Product Revision Notice-Version Change of LCM-40DA/60DA

2014.03.11

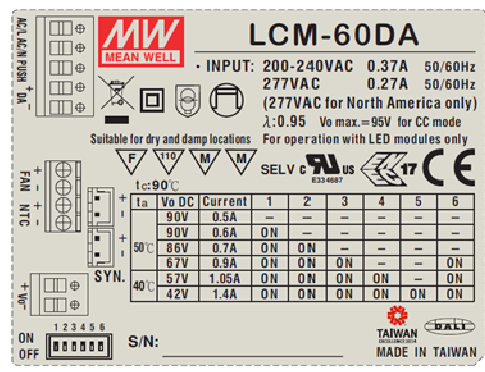
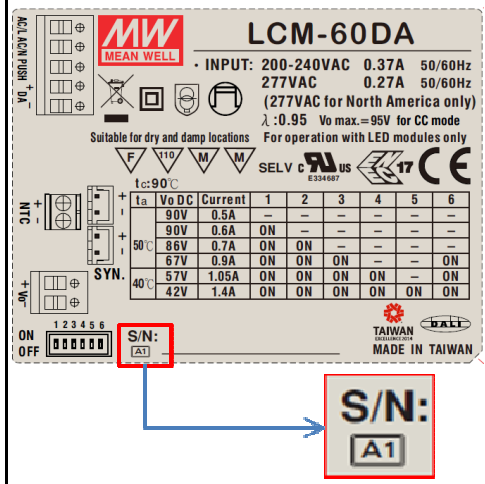
In order to fulfill the requirement for lighting systems, MEAN WELL upgrades the LCM-40DA/60DA series by shortening the setup time from its original “1200ms/230VAC” to “500ms/230VAC”. In addition, to meet the latest ErP requirement for end lighting systems about no load power consumption <0.5W, the existing auxiliary output “12V/50mA” needs to be canceled.

Item	Before	After
Product Version	Blank	A1
label		
Setup Time	1000ms/230VAC	500ms @230VAC
Auxiliary Power	12V/50mA	None
No Load Power Consumption	<1.2W	<0.5W
